Report on Consultation (Alignment Stage)
Connagill Cluster Grid Connections
September 2024

REF: LT559, LT560, LT319, LT522, PT961
and LT421

Title: Figure 1 - Combined Connagill Cluster - Optimal Alignments

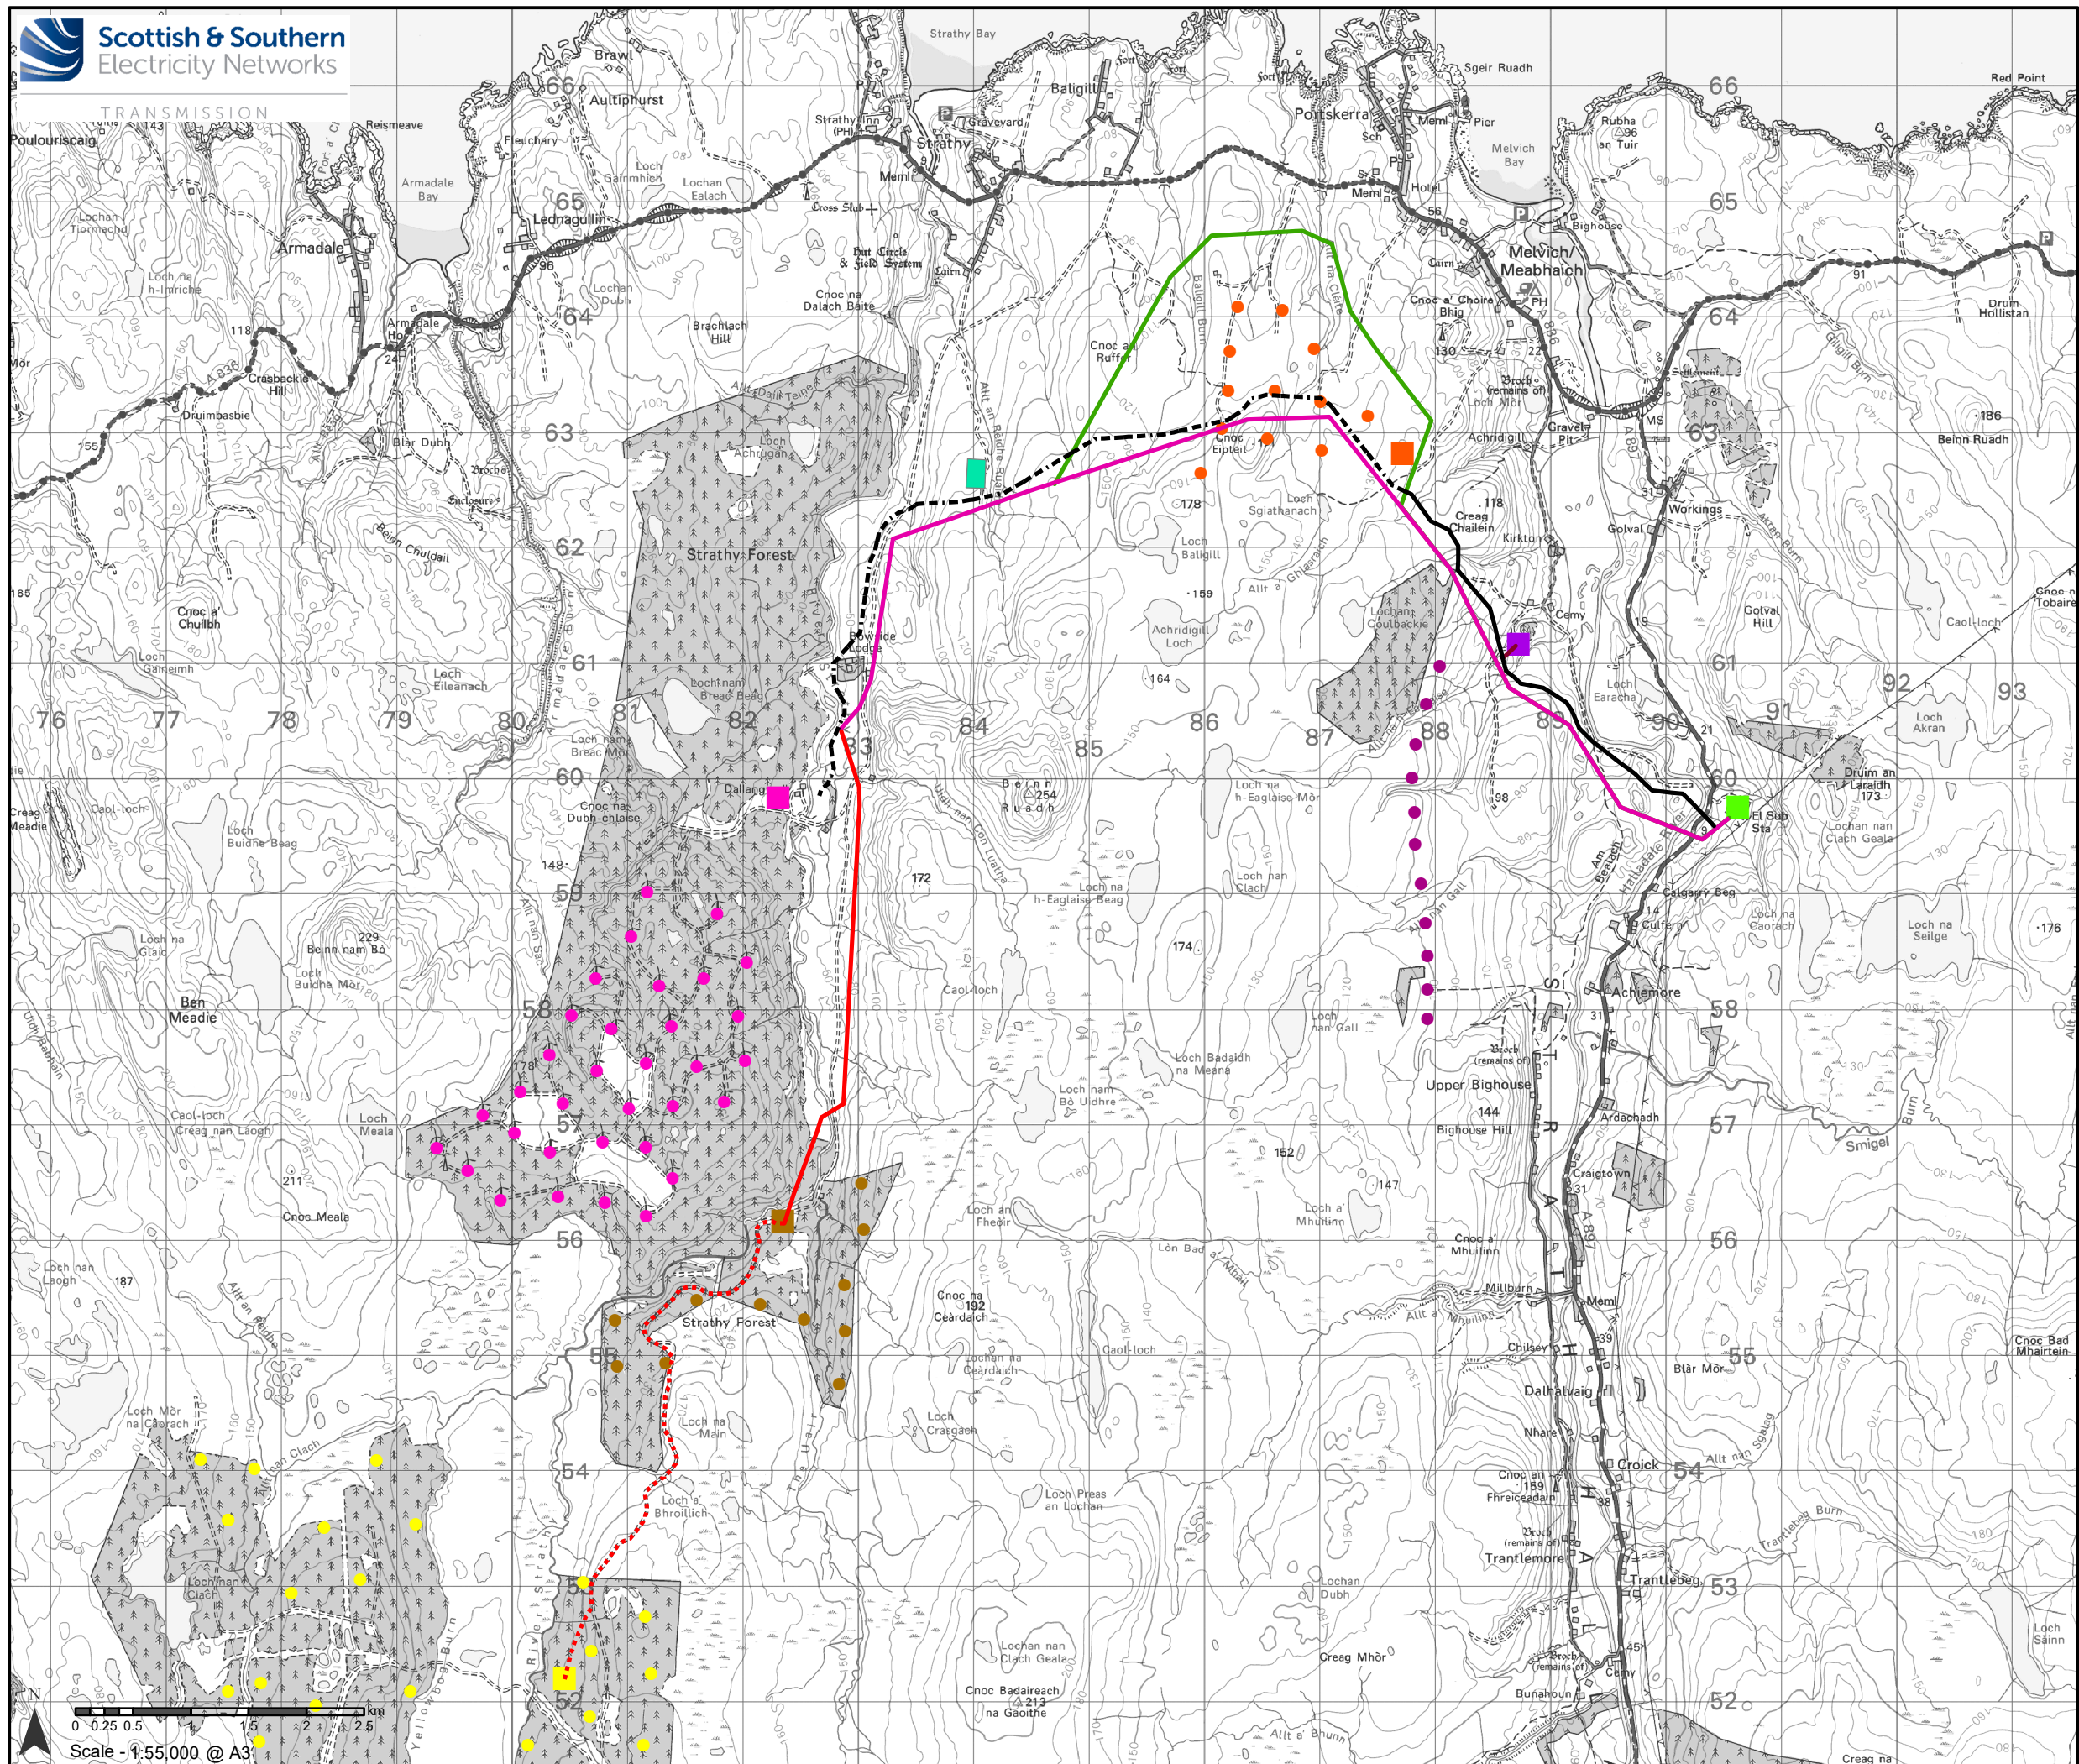
SEPA outlined that in relation to flood risk, it appears that neither Site A nor Site D have been assessed in relation to the neighbouring watercourses and suggest that flood risk is assessed before an optimal site is identified.	<p>This comment is acknowledged.</p> <p>SSEN Transmission intend to model the flood risk associated with the Allt an Reidhe Rudidh watercourse, which is in proximity to the optimal site (Site Option A) to establish the floodplain extent both now and, in the future. This data will be used to inform the design of the switching station.</p>

Stakeholder	Summary of Feedback	Response by SSEN Transmission
	<p>SEPA noted that the following statements in the Consultation Document are confusing and it is not clear how the conclusions have been reached: ‘Site Option A is not considered to be at flood risk, however, it is likely that flood risk associated within the Allt an Reidhe Rudidh has not been modelled by SEPA (and this would need to be established if the option was to be taken forward). Site Option D: has a greater potential for flood risk due the proximity of a nearby watercourse’.</p>	<p>As set out above, SSEN Transmission intend to establish the flood risk associated with the Allt an Reidhe Rudidh watercourse, which is in proximity to the Optimal Site (Site Option A), to inform the siting and design of the switching station.</p>
	<p>SEPA have made no comments at this stage on the alignments for the Strathy South and Strathy Wood Grid Connections – Southern Section; Strathy South and Strathy Wood Grid Connection – Northern Section; or Kirkton Grid Connection.</p>	<p>This is noted.</p>

Historic Environment Scotland (HES)	Strathy Wood and Strathy South - Northern Section	
	<p>HES are content that the Optimal Alignment as identified in the Consultation Document would not raise significant impacts for our remit.</p>	<p>These comments are welcomed.</p>
	Strathy Wood and Strathy South - Northern ‘Alternative’ Section	
	<p>HES suggest that the Optimal Northern ‘Alternative’ Alignment has the potential to impact on the setting of category A listed Bighouse, garden pavilion and walled garden (LB7160). HES provided details of the setting of the listed building and the potential impacts of the connection on the setting of this asset in their Routeing Stage response.</p> <p>HES recommend that photomontages are produced to demonstrate and support the assessment of impacts on the setting of this asset.</p> <p>HES have separately responded to a consultation regarding the details of the location for this visualisation and have provided details of a location to show the view from the garden pavilion looking west along the designed axial view towards where the proposed OHL may be visible.</p>	<p>As confirmed with HES in separate consultation, SSEN Transmission are happy to produce a visualisation from Bighouse garden pavilion (from an agreed viewpoint location) to be included within the EIA Report for the Alternative Alignment.</p>

6.3.2 HES suggested that the Optimal 'Alternative Northern' Alignment has the potential to impact on the setting of Bighouse Garden Pavilion and Walled Garden (a Category A listed building). SSEN Transmission have consulted with HES separately confirming that a visualisation will be produced in support of the EIA Report for the 'Alternative Alignment' and have agreed the viewpoint location from within the garden pavilion.

6.5.1 SEPA raised concerns with the optimal site (Site A) presented in the Consultation Document due to it being located on peat depths recorded to be of 2 m or less. SEPA noted a preference for Site Option D, as it is located on much shallower peat depth (less than 0.4 m).

6.5.2 Whilst this is acknowledged, there are engineering challenges with Site Option D that make this less preferred. This include the irregular shape of the site meaning it would be unable to accommodate all technology types

without modification or relocation; the undulating ground requiring significant earthworks to construct; the 'tucked in' position of this site in relation to surrounding topography posing issues of tie-in for future connections; and being directly on the alignment of the proposed Strathy North to Connagill 132 kV OHL would require the OHL to be temporarily diverted while a switching station is constructed at this location. For these reasons, SSEN Transmission will not be progressing Site Option D.

- 6.5.3 Nevertheless, as the design for the switching station is developed, peat depth data will be considered to refine the design and minimise impacts on peat, where possible. In addition, SSEN Transmission will model the flood risk associated with the Allt an Reidhe Rudidh watercourse, which is in proximity to the optimal site, to establish the floodplain extent both now and in the future, and this will be used to inform the design of the switching station.
- 6.5.4 No further specific comments were received from stakeholders on the site options presented in the Consultation Document. Subject to the outcome of the flood risk modelling, SSEN propose that the optimal site (Site Option A) be taken forward as the proposed site.
